Re: Scurry County Courthouse - Structural Assessment
Snyder, Texas
JQ Project No. 3230107

Scurry County Courthouse - Structural Assessment, Snyder, Texas

Photograph 5 – Approximate 1 1/4 inch lateral displacement at granite panel on south elevation.

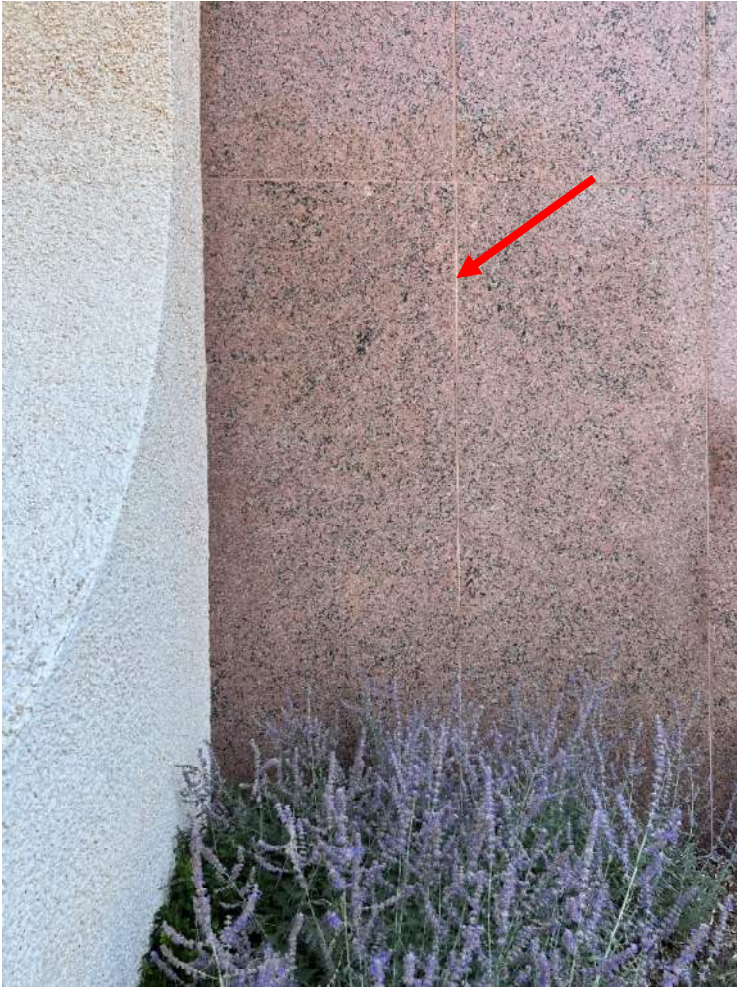
- One (1) panel on the south elevation has shifted outward approximately 1 inch at the top of the panel and 1 1/4 inch at the bottom of the panel. At this location, the lateral ties for the panel appear to have detached from the supporting precast concrete beam. Refer photographs 5 and 6.

Based on observations at the three (3) granite panels which have experienced lateral displacements and absent cracking or spalling of the stone, the pins at the base of the displaced panels appear to be missing and the lateral restraint at the top of the panels appear to have become dislodged from the supporting precast concrete beams. Absent installation of new lateral restraints, the displacement of these panels may continue to increase. Therefore, supplemental lateral connections should be installed at these locations.

- The one (1) granite panel on the south building elevation which has laterally displaced over 1 inch should be reset into proper alignment with the adjacent panels. The top and bottom of this panel should then be reattached to the supporting structure with steel angles attached with anchors drilled and set with epoxy into the back of the panels and into the supporting structure to provide lateral restraint. Damaged joint sealants around the perimeter of the panel should be replaced.

South Elevation

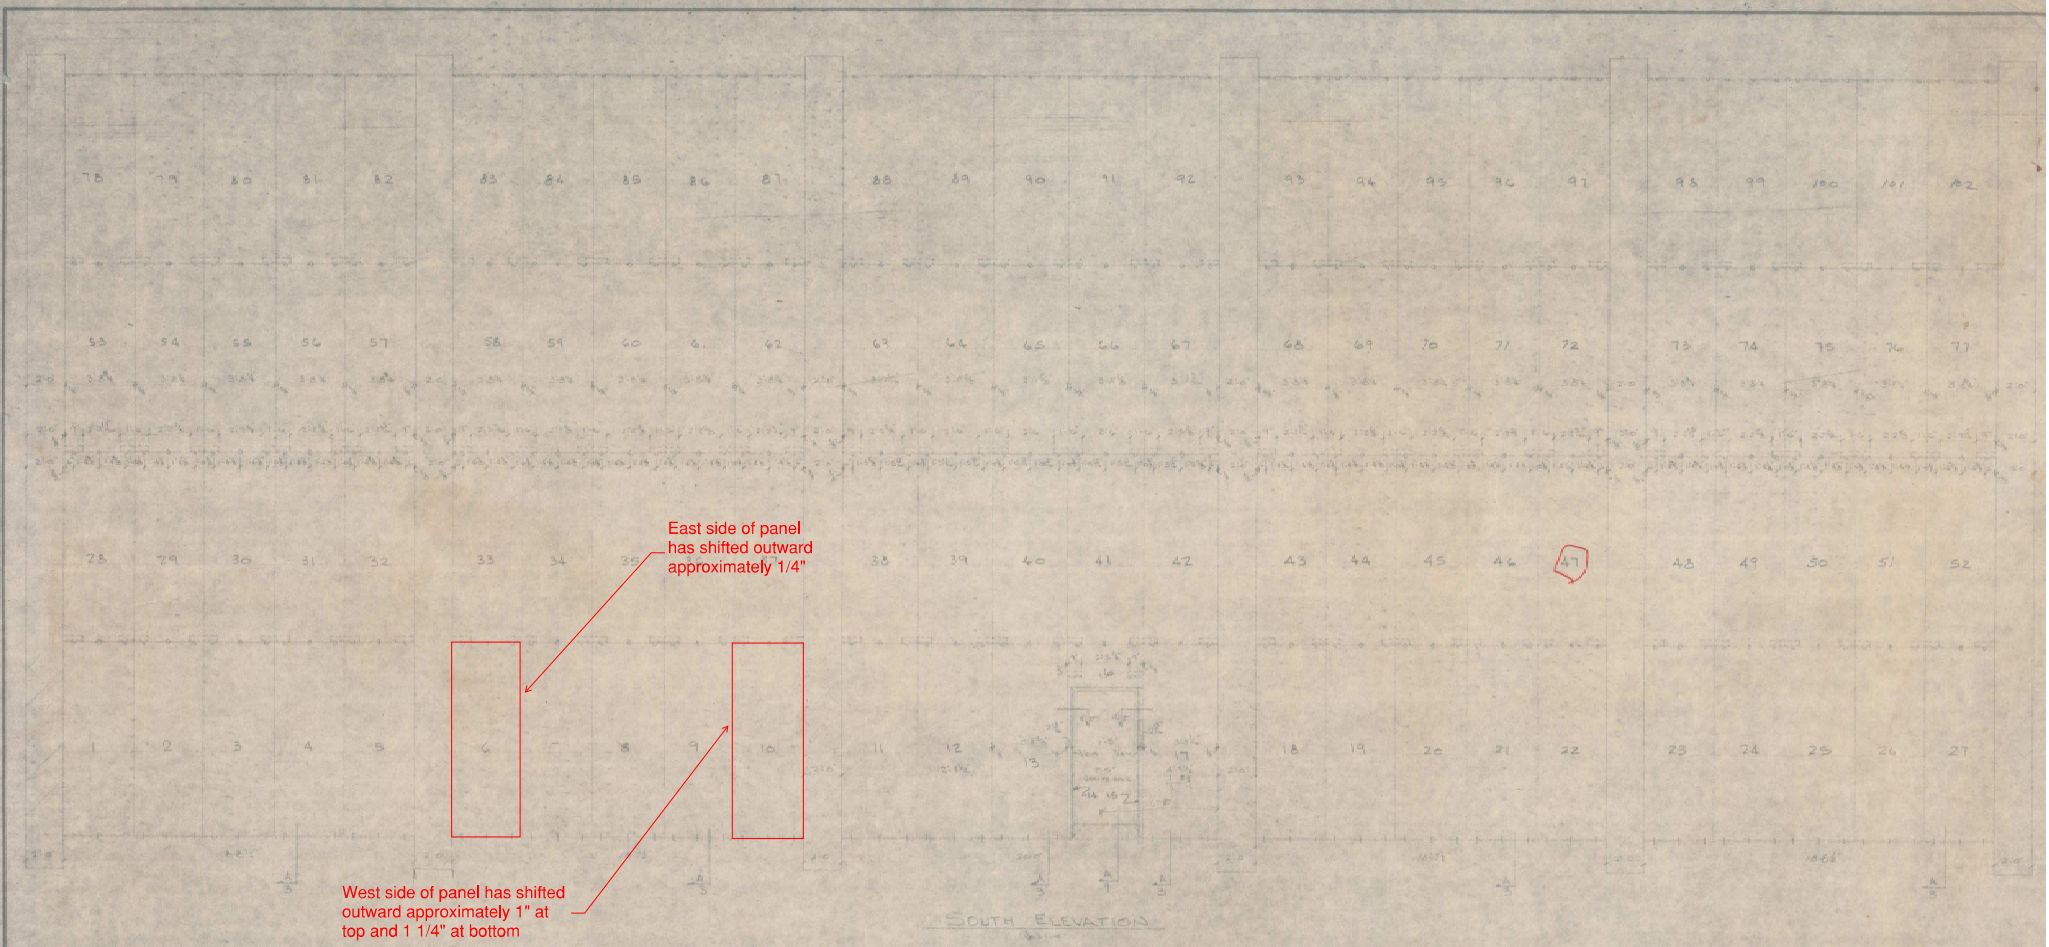
East side of panel
has shifted outward
approximately 1/4"

West side of panel has shifted
outward approximately 1" at
top and 1 1/4" at bottom

- The two (2) granite panels which have laterally displaced 1/4 inch or less do not require relocation. However, the top and bottom of each panel should be reattached to the supporting structure with steel angles attached with anchors drilled and set with epoxy into the back of the panels and into the supporting structure to provide lateral restraint. Damaged joint sealants around the perimeter of the panel should be replaced.

North Elevation

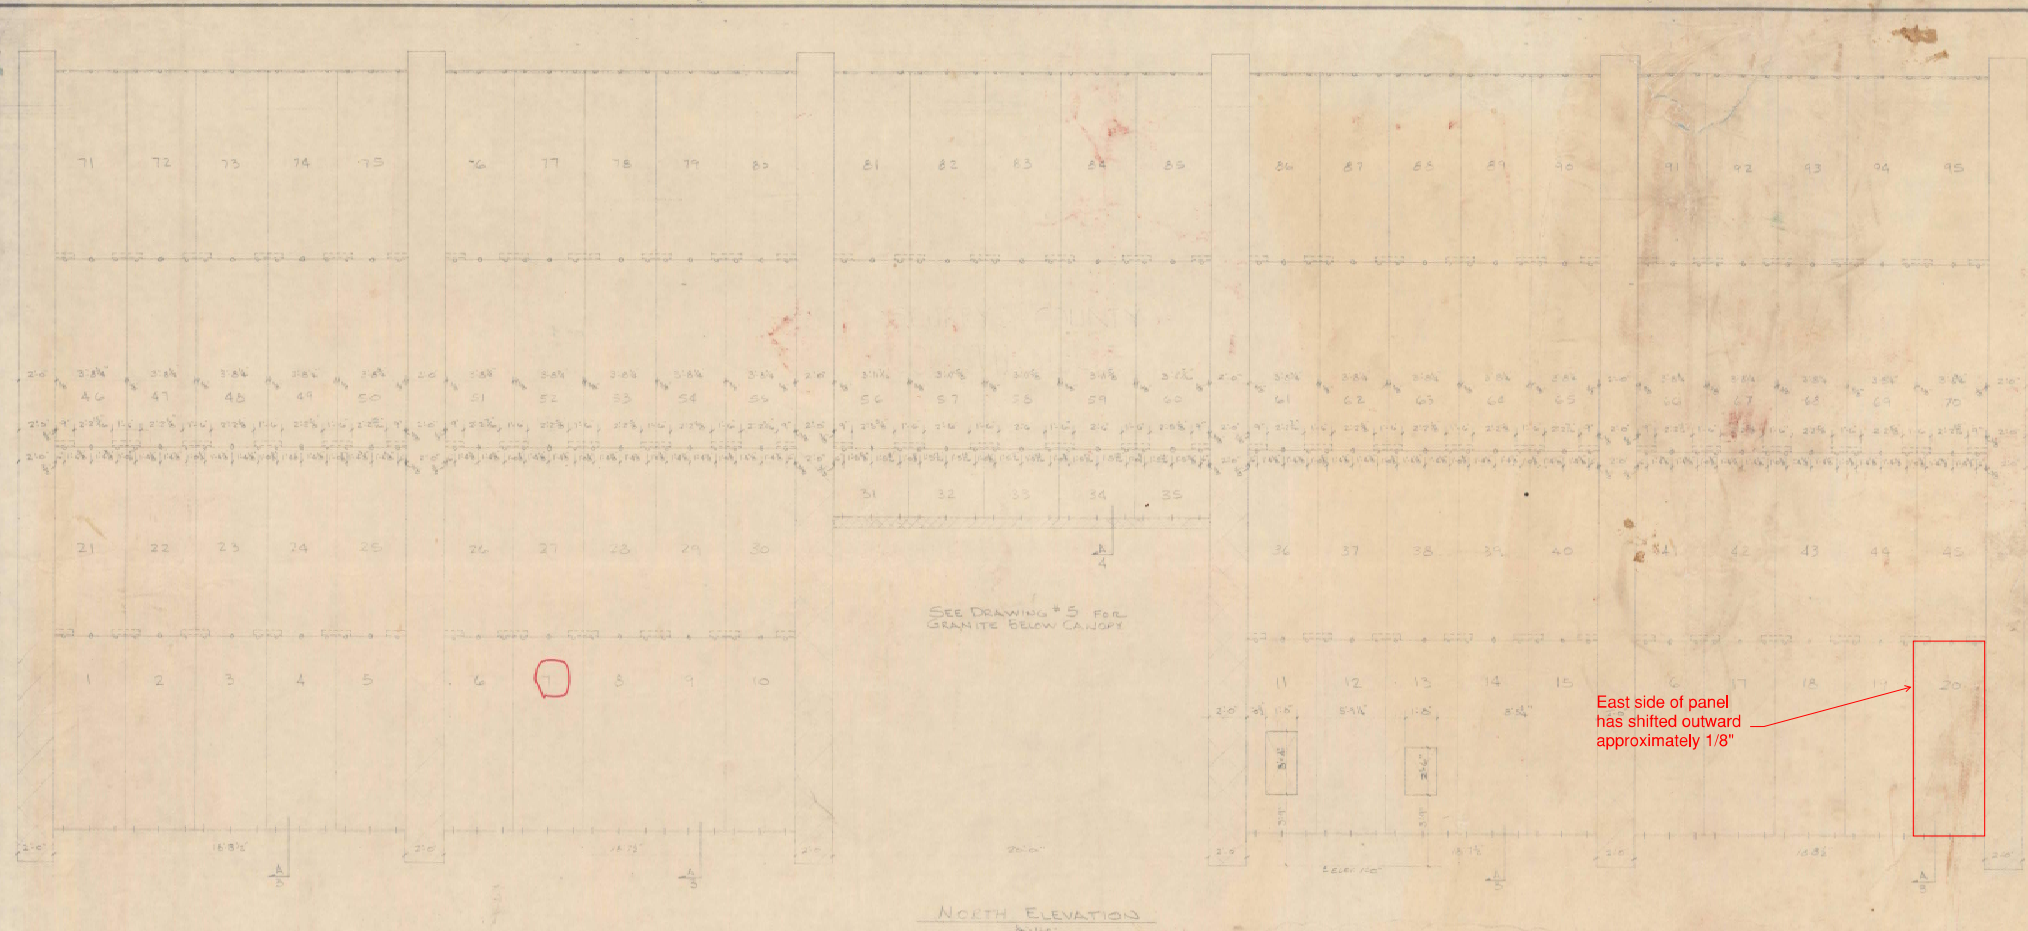
East side of panel has shifted outward approximately 1/8"

Typical Connection Details

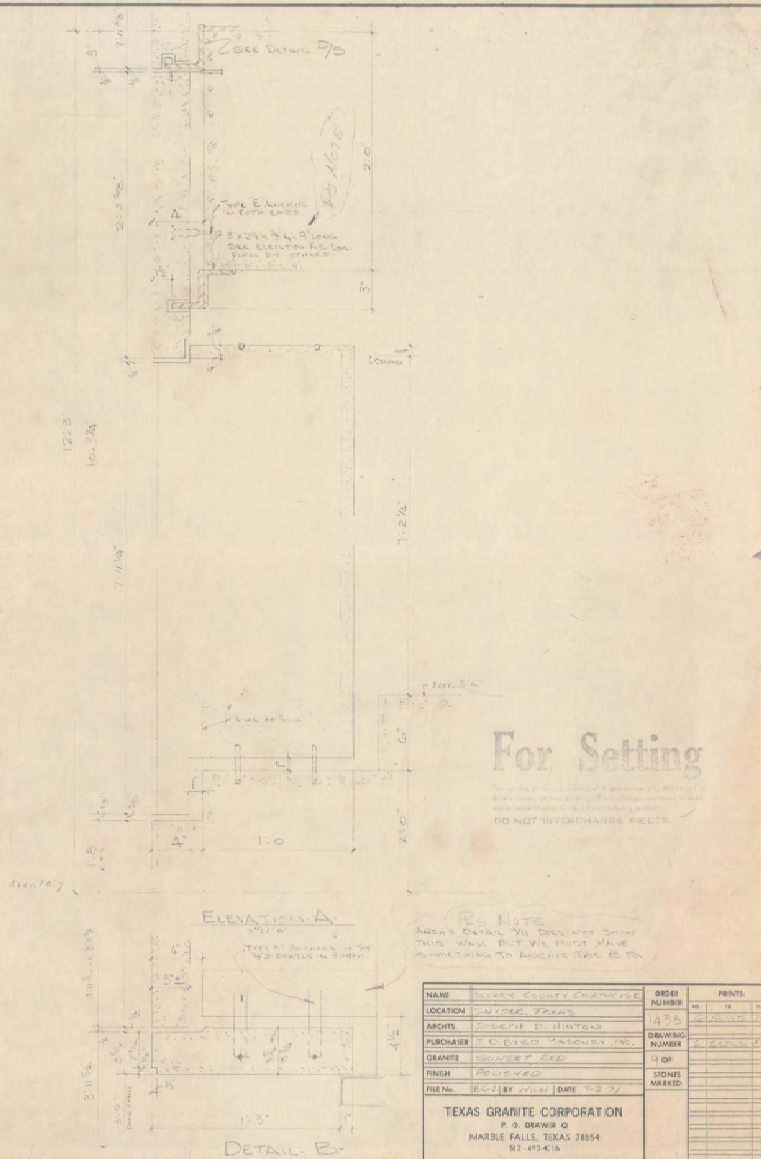
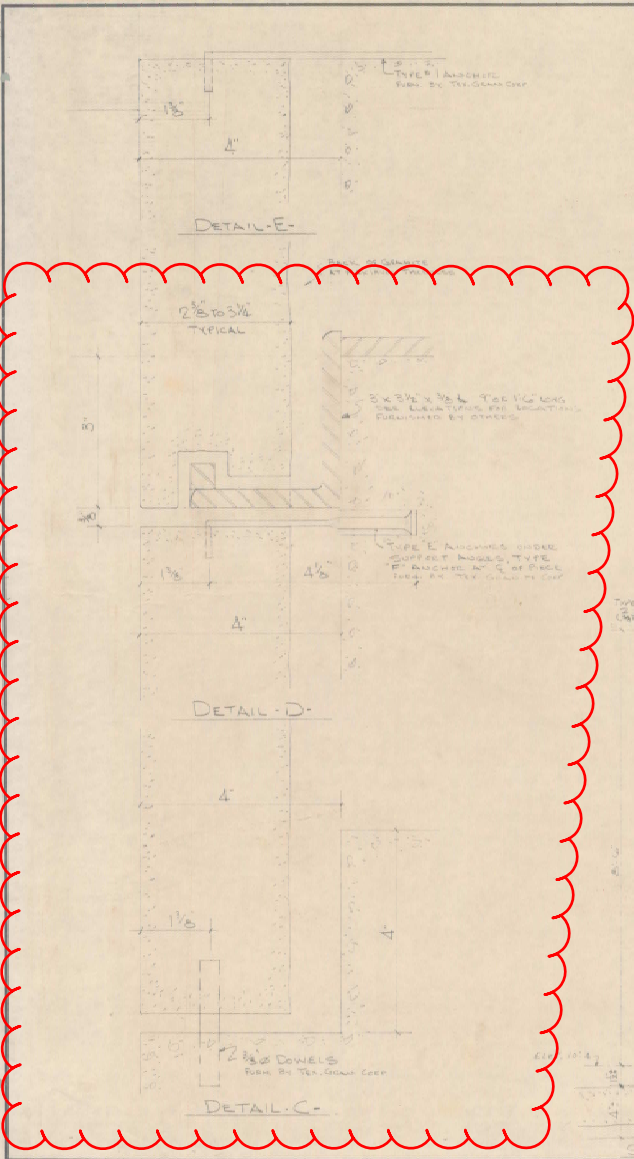
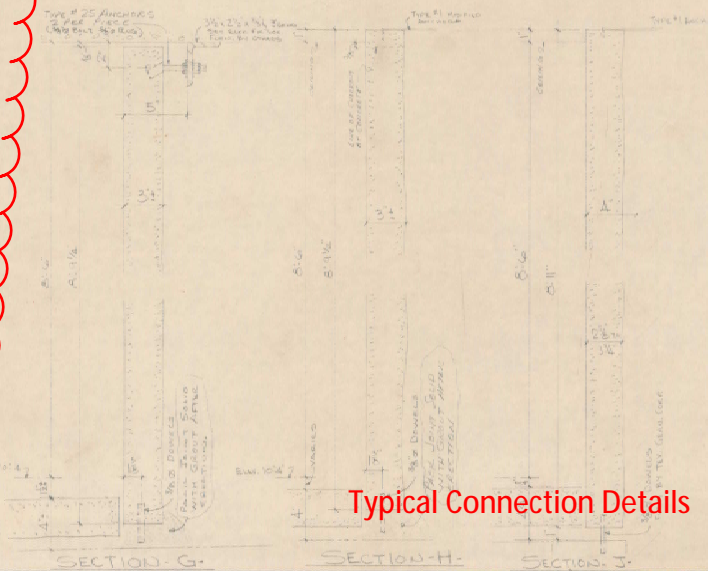
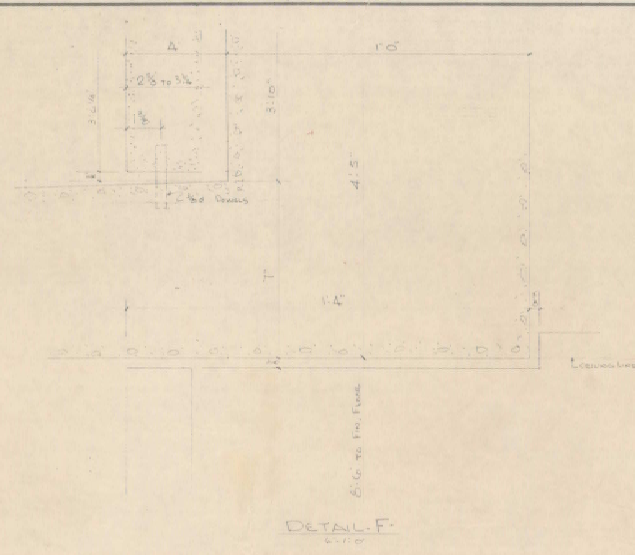
Per the original granite installation drawings, the base of the granite panels at the bottom of the exterior walls are laterally restrained by a vertical steel dowel drilled and set into the concrete foundation and projecting upward into a drilled hole in the base of the stone. At elevated joints, the top of the granite panels are laterally restrained by a bent steel tie which is drilled and set into the supporting precast concrete beams and the bottom of the panels are vertically and laterally supported by a steel angle set into a kerf cut into the base of the stone and welded to embedded steel plates in the supporting precast concrete beams. These types of connections were typically used at the time of granite panel installation. The connections are depicted in the attached original typical connect details drawing.
